DMURS Report and Statement of Design Consistency

Proposed Strategic Housing Development at Belcamp, Dublin 17

April 2022

Issues Raised in This Stage 1 Road Safety Audit

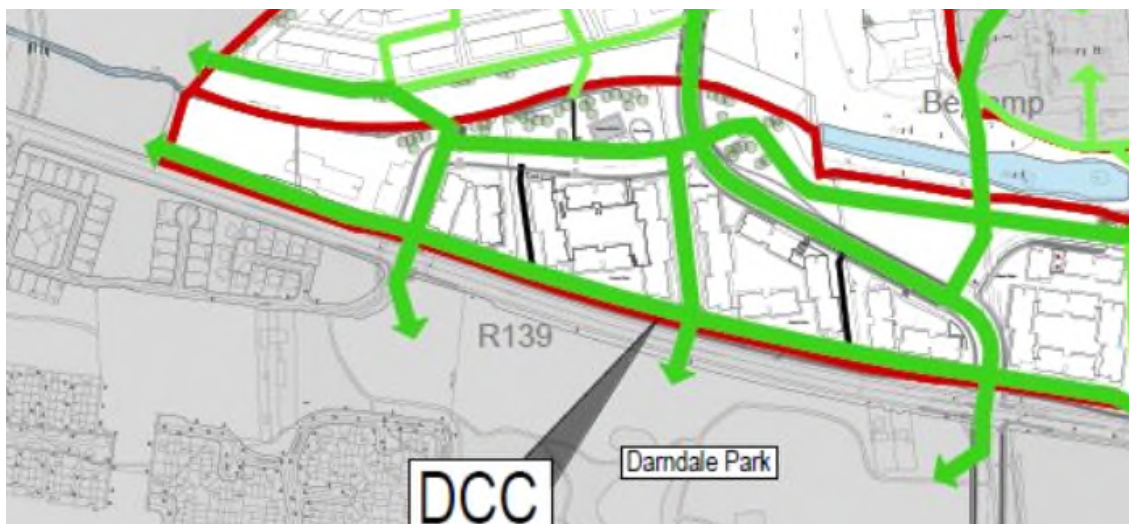
The provision of two new junctions, three main pedestrian routes and three main cycle routes will change the nature of the R139 from its existing outer relief road character. Without adequate design features this could remain a high speed link into the M50 for frustrated drivers that have been delayed at Clarehall Junction.

It is recommended that the R139 be treated as a DMURS road and additional features (landscaping, etc.) be added to make the driver feel that they are travelling along such a road. The straight horizontal and relatively flat vertical alignment will remain but do not support this change. A gateway treatment and transition zone would be appropriate at the start of the development site.

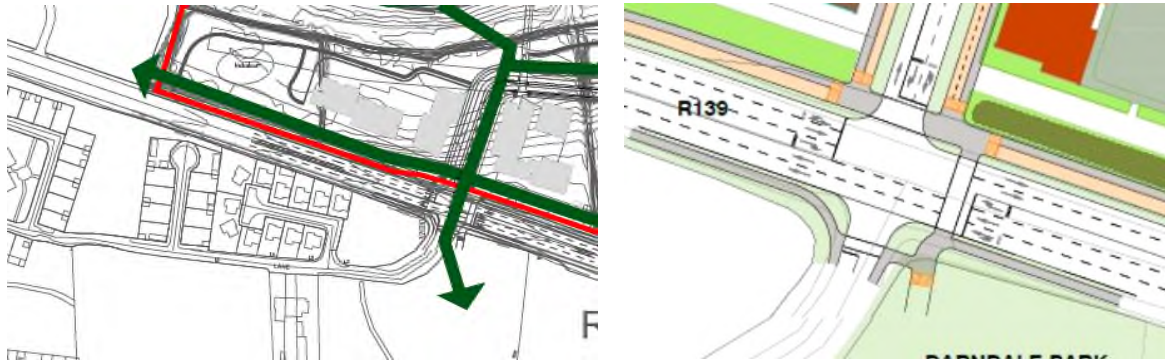
The existing cycle facilities on the Malahide Road north of Clarehall Junction are not continuous and vary in quality. The lack of connectivity from the proposed development to the higher quality cycling facilities south of Clarehall junction may lead to an increased use of cars to transport younger or less confident cyclists.

It is recommended that the R107 cycle route 'by others' is designed and implemented prior to full occupation of the development. If the applicant has no control of the elements to be 'designed by others' then temporary alternatives may need to be developed for the shorter and medium term to ensure that from first occupation that high quality cycle facilities are provided. It is noted that works are ongoing in this area and committed works are planned so the environment will improve from that observed during the site visit which included much temporary traffic management.
